D E S I G N
R E V I E W
C O M M I T T E E
S T A F F R E P O R T

2587 Telegraph Avenue

FINAL DESIGN REVIEW

Design Review #DRCF2024-0005 to demolish a two-story retail building and construct an eight-story (95-foot) 112,562 square-foot mixed-use residential building with 52 dwelling units, including six (6) Very Low-Income Density Bonus Units, 2,903 square feet of ground floor commercial, and 73 long term and six (6) short term bicycle parking spaces.

STREETSCAPE ELEVATION - PROPOSED

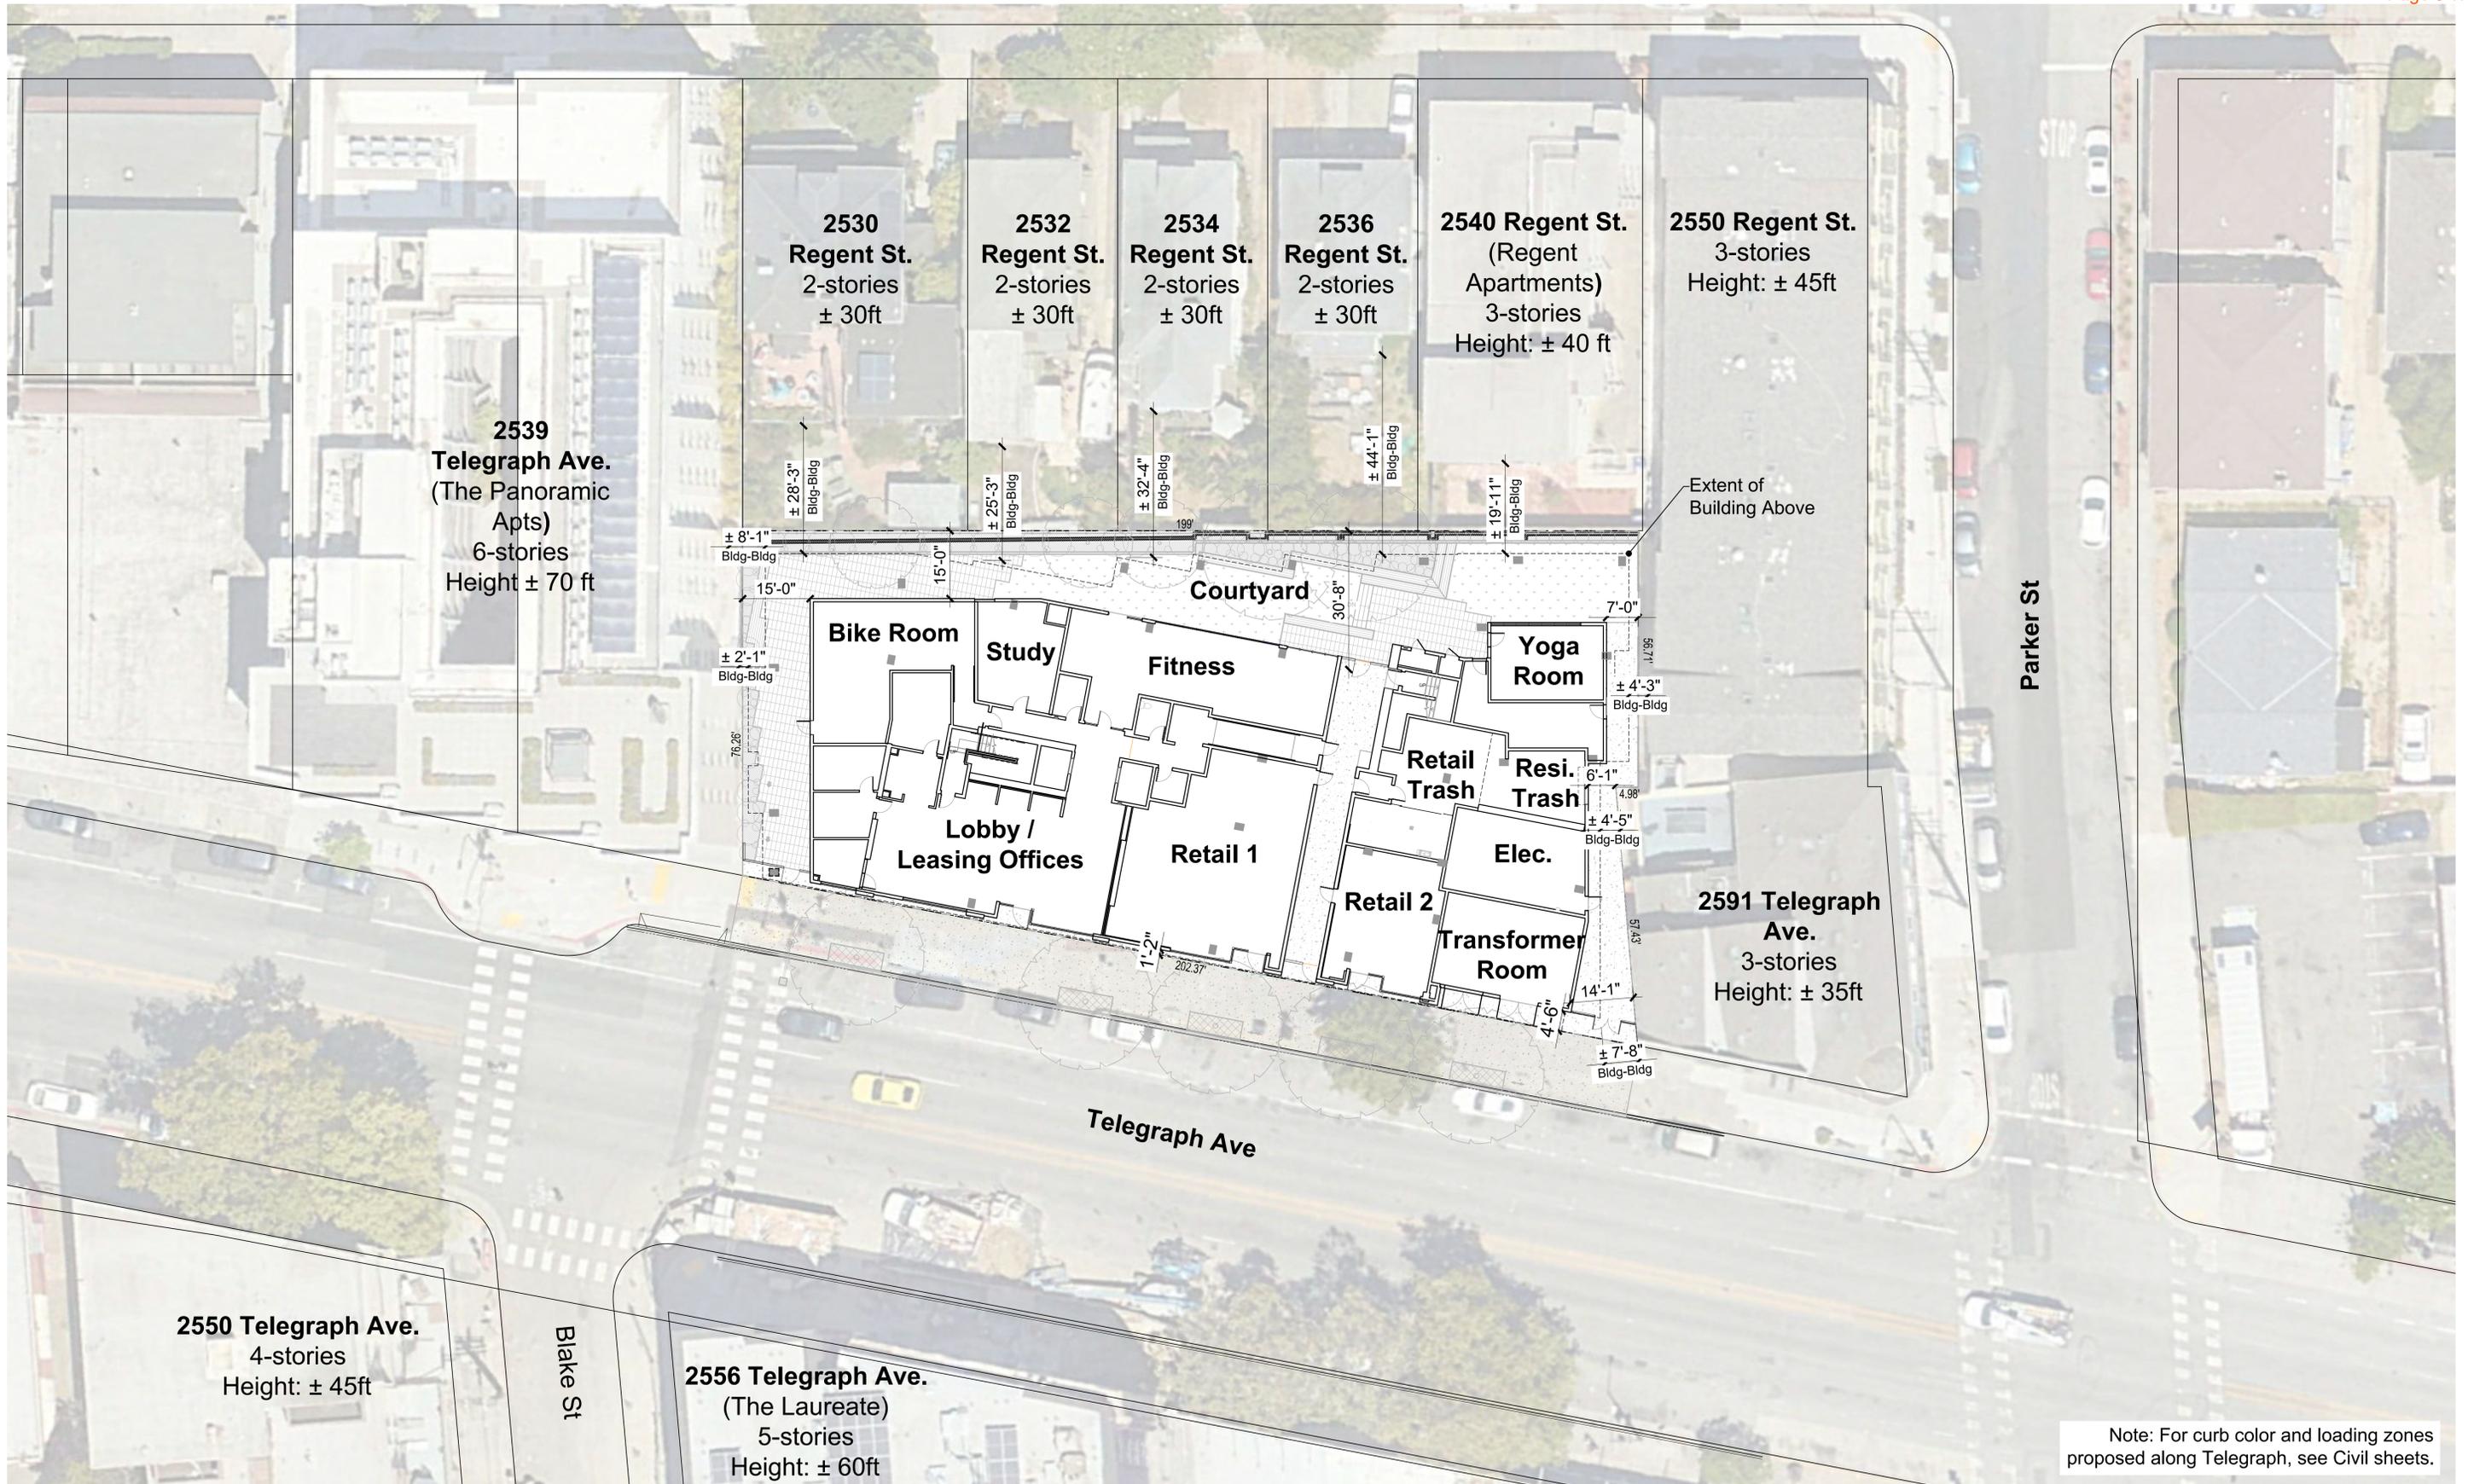
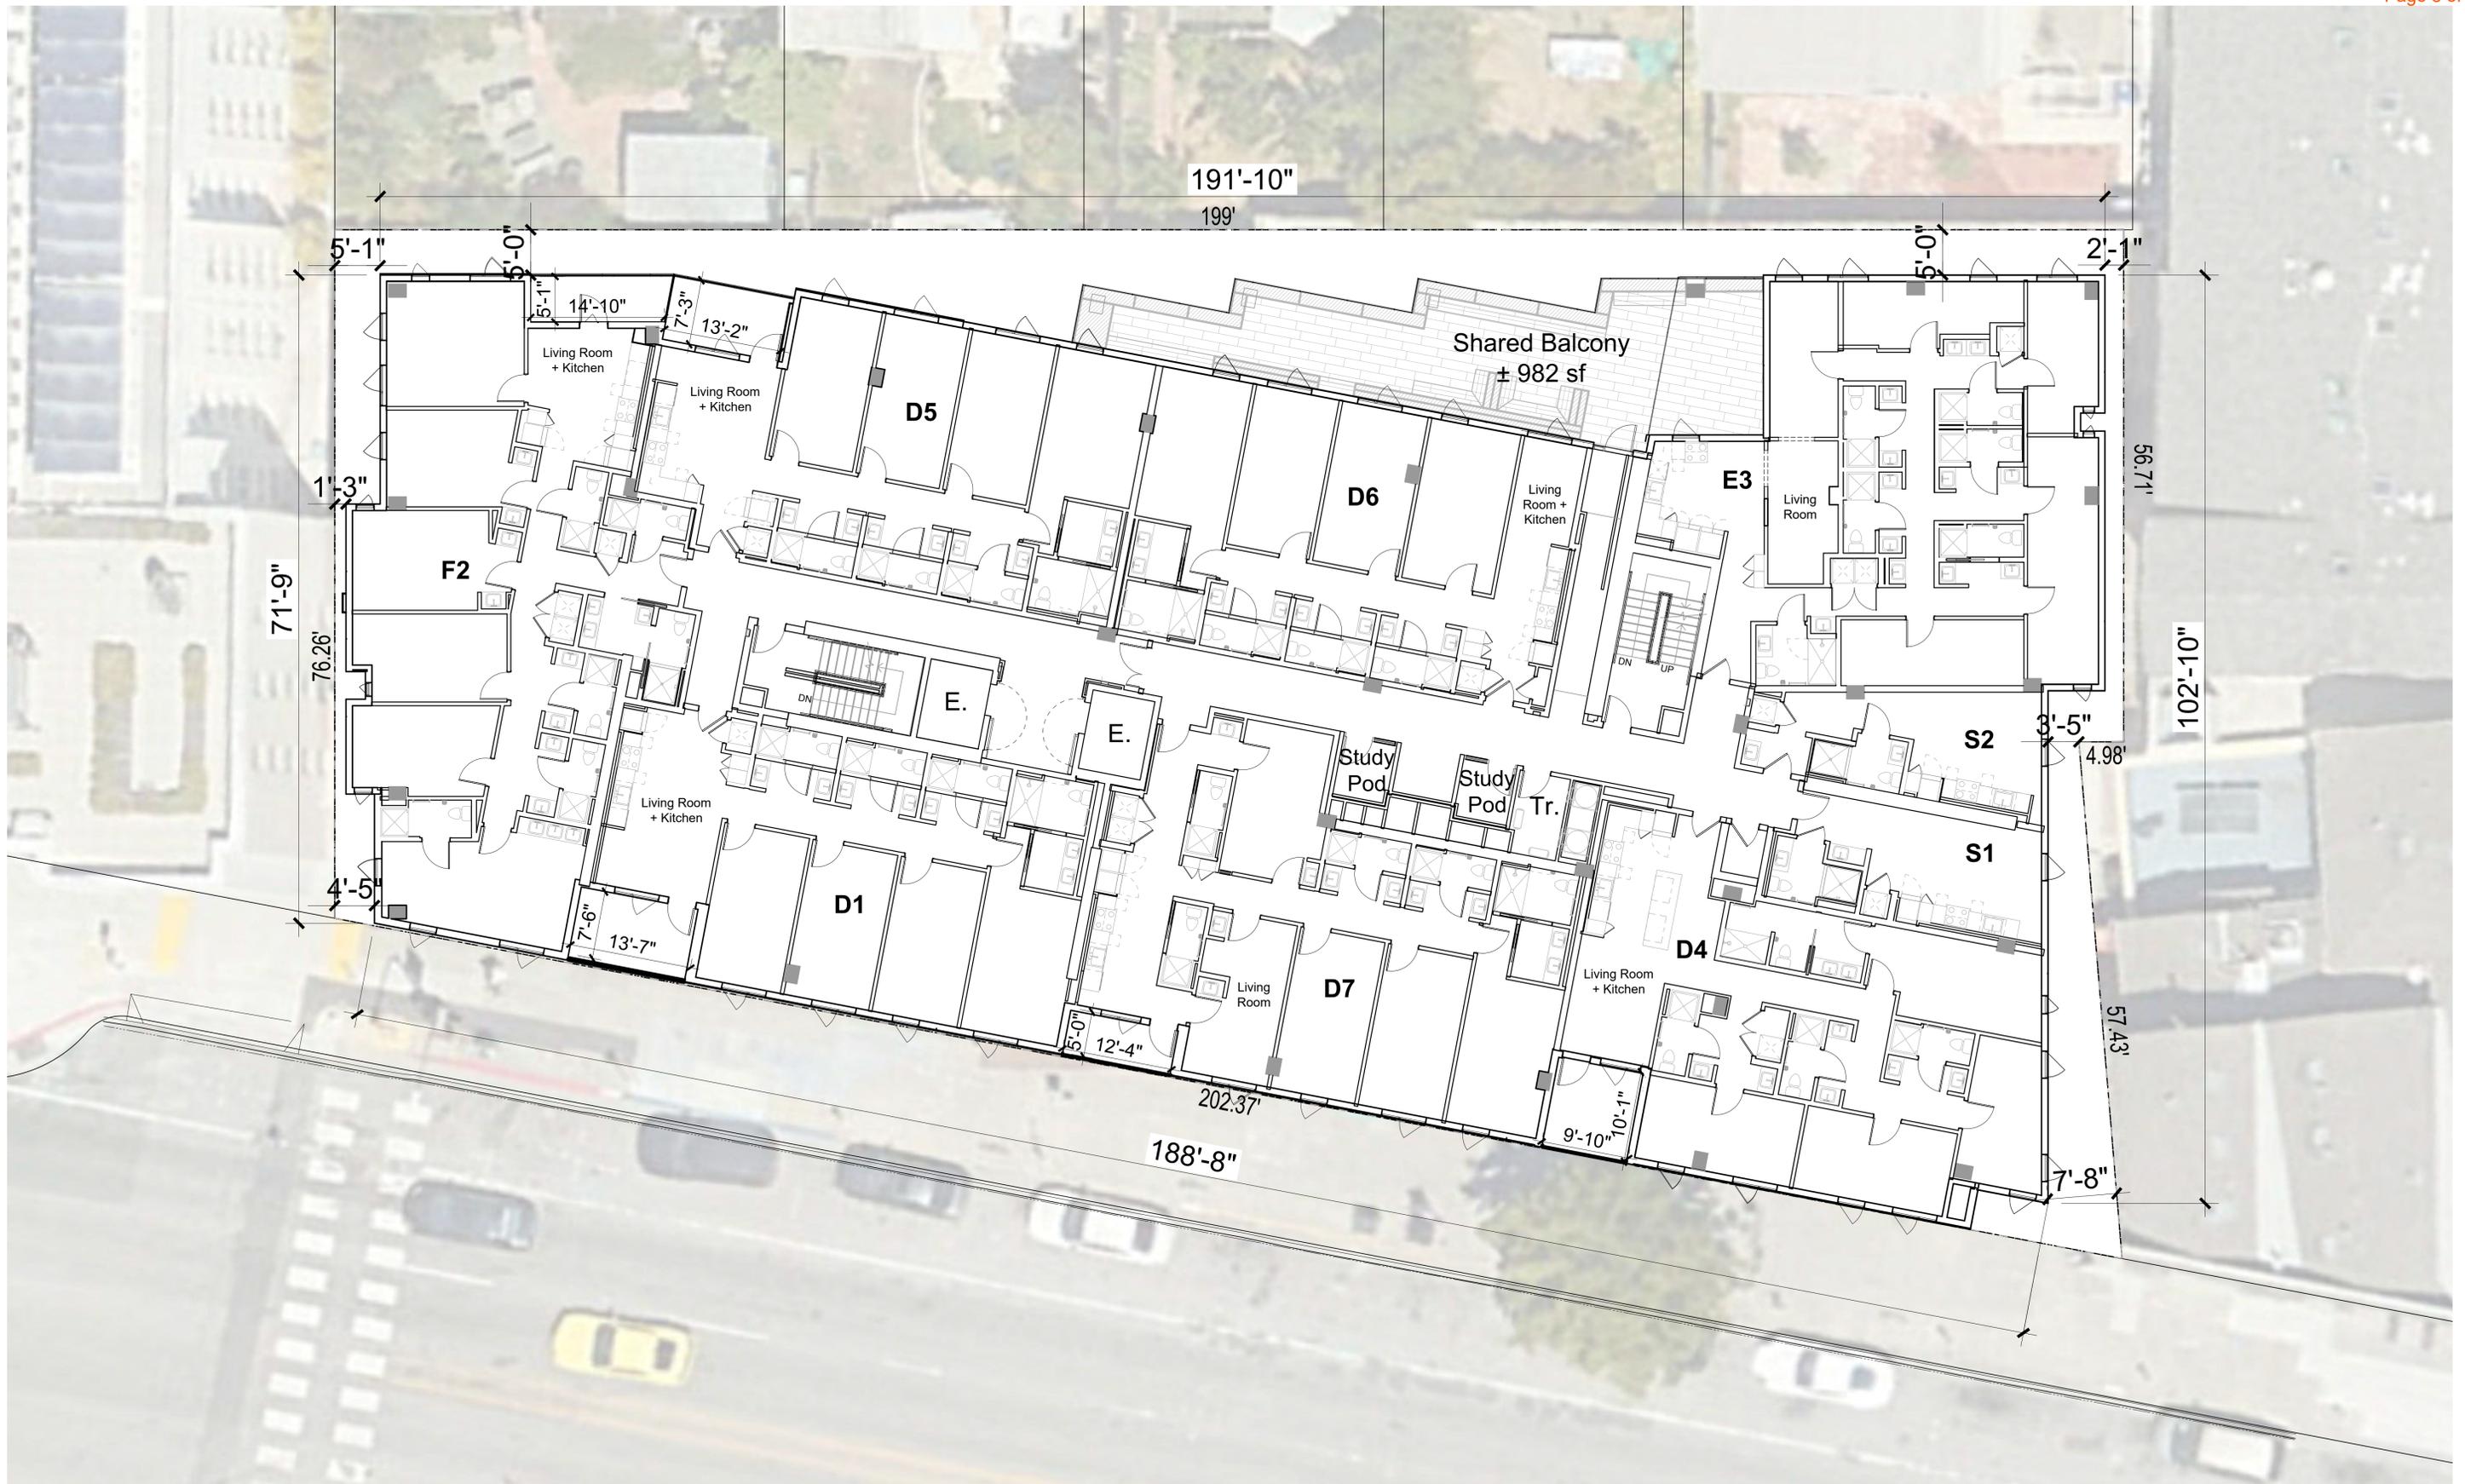
3	<i>Visually raise the ground floor, or at least bring study of how this building transitions with adjacent structures.</i>	A0.3, A2.0	The ground floor has been pulled forward to reduce the previously proposed 4ft-5ft overhang. Now the 12" vertical jog mitigates the feeling of being "compressed" as it relates to adjacent structures. To visually achieve a two-story ground floor expression, the wood material, window modules, and architectural detailing are consistent with the ground floor.
4	<i>Study the first floor and accurately show the grade change in the elevations. Call out the height to the bays.</i>	A5.8	The building overhang has been eliminated. With this new revision to the ground floor, the bays have been removed and the proposed grade and heights have been provided.
5	<i>Windows on the west façade should have more logic, but also less repetition.</i>	A0.3, A2.0	The windows on the West façade have been aligned to establish a visual vertical line, creating a sense of order and structure. This alignment provides vertical consistency while still allowing the windows to vary in placement per pair of levels, adding visual movement across the entire façade.
